### APPEAL SUMMARY

<b>Appeal ID:</b> 22255	<b>Project Address:</b> 1528, 1530, 1534, 1536 N Blandena St
<b>Hearing Date:</b> 12/18/19	<b>Appellant Name:</b> Paul Wolfe
<b>Case No.:</b> B-015	<b>Appellant Phone:</b> 503-954-3065
<b>Appeal Type:</b> Building	<b>Plans Examiner/Inspector:</b> Geoffrey Harker
<b>Project Type:</b> commercial	<b>Stories:</b> 4 <b>Occupancy:</b> R-1 <b>Construction Type:</b> V-A
<b>Building/Business Name:</b> Homestead at Pittman Park Hotel	<b>Fire Sprinklers:</b> Yes - NFPA 13 Throughout
<b>Appeal Involves:</b> Addition to an existing structure, occ Change from R-2 to R-1	<b>LUR or Permit Application No.:</b> 14-254719-CO
<b>Plan Submitted Option:</b> pdf [File 1]	<b>Proposed use:</b> Transient Dwelling (Hotel/Motel)

BUILDING CODE		
PROJECT NAME:	Homestead at Pittman Park Hotel	
ADDRESS:	1532 N Blandena St., Portland, OR 97217	
LOCATION:	100' west of Interstate Ave on Blandena St.	
TAX LOT NUMBER(S):	R158278	
LEGAL DESCRIPTION:	Lots 9 + 10, Block 2, Erwin + Watson's Addition situated in the northeast one-quarter of Section 21, Township 1 North, Range 1 East, Willamette Meridian, City of Portland, Multnomah County, Oregon	
CODE:	2019 Oregon Structural Sp

Existing/Proposed Second Floor Plan  
Scale: 3/32" = 1'-0"

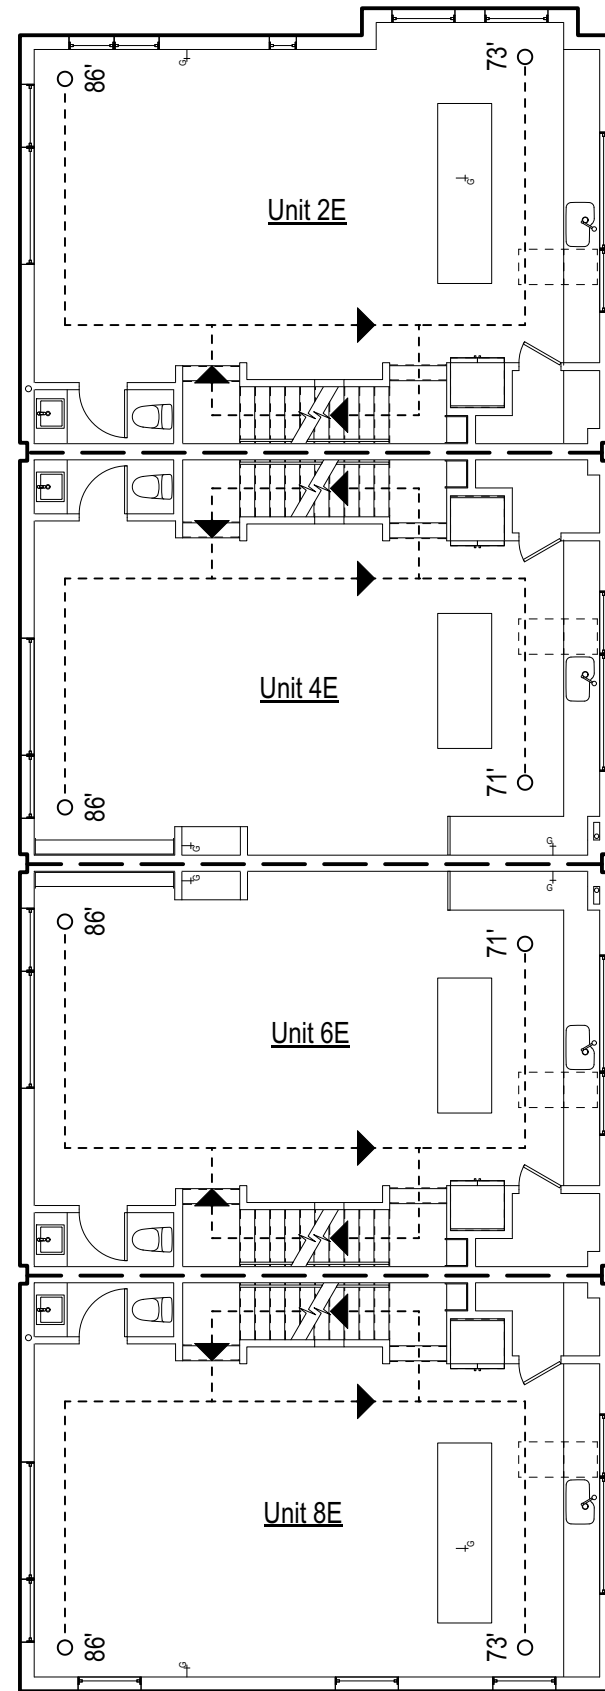
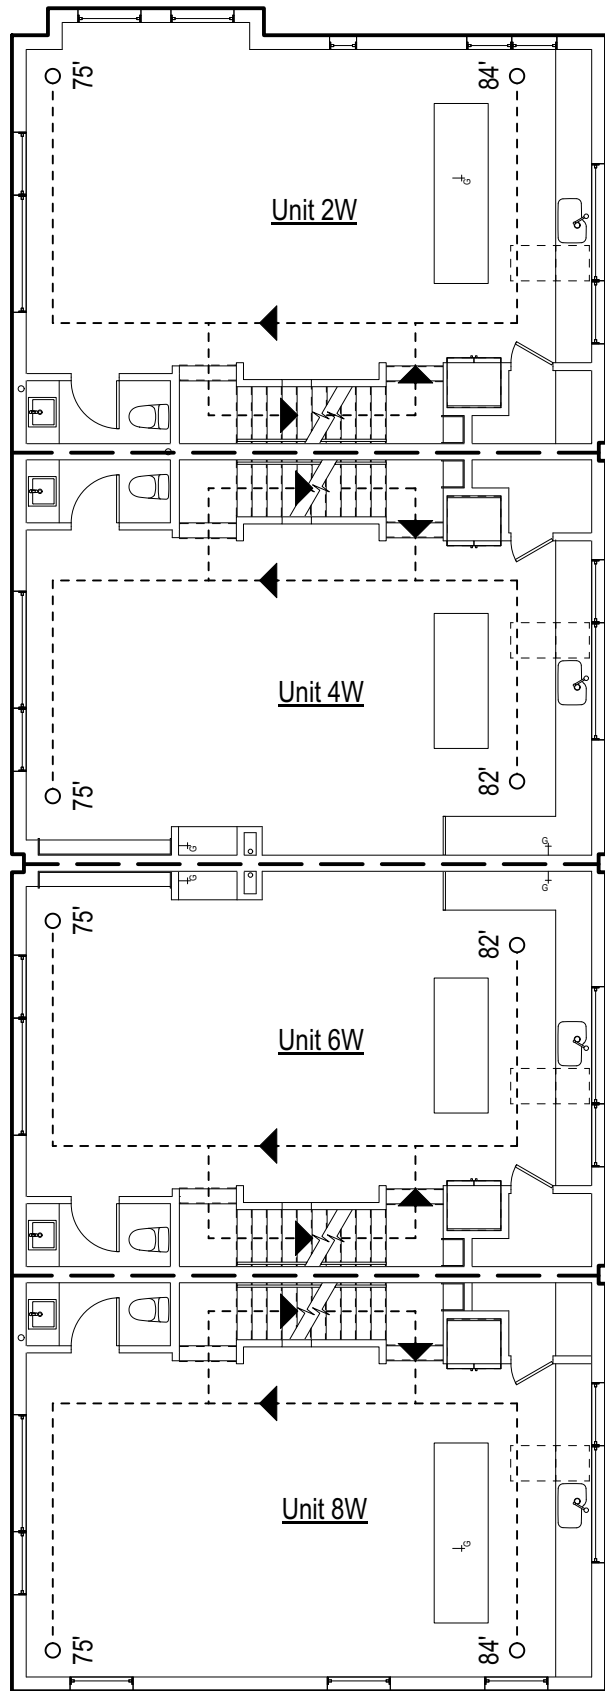
<b>Code Section</b>	2019 OSSC 1006.3.3.5.1
<b>Requires</b>	<p>Individual single-story or multistory dwelling units shall be permitted to have a single exit or access to a single exit from the dwelling unit provided that both the following criteria are met:</p> <p>5.1 The dwelling unit complies with Section 1006.2.1 as a space with one means of egress.</p>
<b>Proposed Design</b>	<p>Permit 14-254719-CO and 14-254723-CO established a multifamily residential project of (2) buildings with (4) 4-story units in each building. Both buildings are permitted under the commercial code and equipped throughout with NFPA 13 fire sprinkler systems. This appeal covers the western building on the site and includes addresses 1528, 1530, 1534, and 1536 N Blandena Street. The unit layout for all 4 units in this building is nearly identical.</p> <p>It is proposed that the existing (8) 4-story R-2 units be converted to R-1 occupancy for transient use.</p> <p>Please note that the conversion of these units from R-2 to R-1 will be a phased approach over the course of several permits as existing R-2 tenants run out the course of their leases. The applicant intends to utilize this appeal to apply to multiple permits as all 8 units are converted to R-1 over time. In addition to the conversion of the 4-story units to R-1, the existing garages will be converted to R-1 use; however that is of limited relevance to this appeal as the garage conversions will comply with all code requirements for R-1 and will not share means of egress with the larger 4-story units.</p> <p>The existing units are 4-story and include one central, open stair connecting all 4 stories. The upper story of each unit includes a living area and exterior roof deck. Maximum travel distance as</p>

existing/proposed is 122' from the most remote point of the roof deck area to the exit on the ground floor. Two exits are provided from each R-1 dwelling unit, at ground level, each exiting to a separate side of the building; one exit to the central shared drive court between buildings and one exiting to a sidewalk between the building and the east or west property line. The buildings are equipped throughout with an NFPA 13 fire sprinkler system. Each 4-story unit is separated by a 2-hr rated fire barrier.

**Reason for alternative** Section 1006.3.3.5 allows for multistory dwelling units to have a single exit access provided those units comply with two criteria. Section 5.2 is for the exit to be at the level of exit discharge and our proposal complies with that criterion. Section 5.1 mandates compliance with Table 1006.2.1 Spaces with One Exit. For the reasons outlined below we propose the 4-story R-1 units should be permitted to use the R-2 travel distance of 125' per Table 1006.2.1 rather than the 75' travel distance required for R-1 occupancies.

**Increase in maximum allowable exit access travel distance: Denied. Proposal does not provide equivalent Life Safety protection.**
